Product Change Notification (PCN)

PCN Number	505462	Date Issued	September 07, 2018
Reason for Change	Change to Product		
Change Type Description	This letter is to inform you that changes are being made to the part(s) identified in this Notice. The change may affect the fit, form, function or appearance of the parts, or it may result in a change to the specification. The pictures below show an example of the possible differences.		
Reason for Short Notice	Corrective Actions		
Assessment of Change	First article inspection		
Internal Molex Qualification Date	April 10, 2018		
Sample Availability Date (Changed Part)	April 10, 2018		
Planned Implementation Date	September 30, 2018		
Method of Identifying Change	Date code

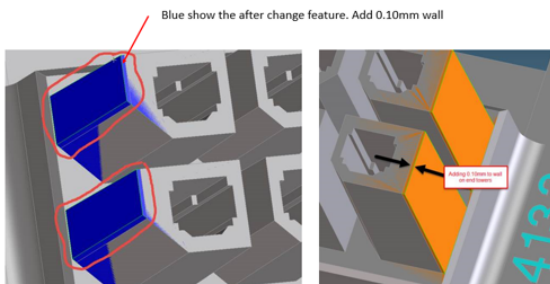
- Add 0.10mm wall

- To reduce the risks of receptacle housing is not guided into full alignment during mating process due to dimensional sizing of parts and/or angle mating and it will cause receptacle housing tower end have stubbing issue when mating.
- Product Impact
 - There is dimension change to the product as the picture.
- Part Number Impact
 - This change will impact to 44133-XX00, 12CKT-24CKT
- Qualification Reports and samples available upon request after the date shown above
